Access Compliance Report

Public Rights-of-Way

(Pedestrian Signals)

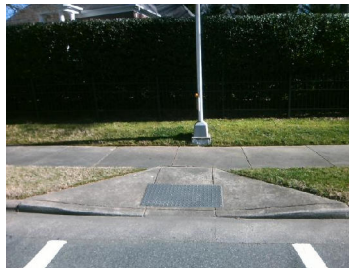
Possible Solutions: Replace Signal Push Button With APS Button on New Post. Remove & Relocate Sign.

PROW/ADA: TMUTCD 4e.08, R404.2, R404.3
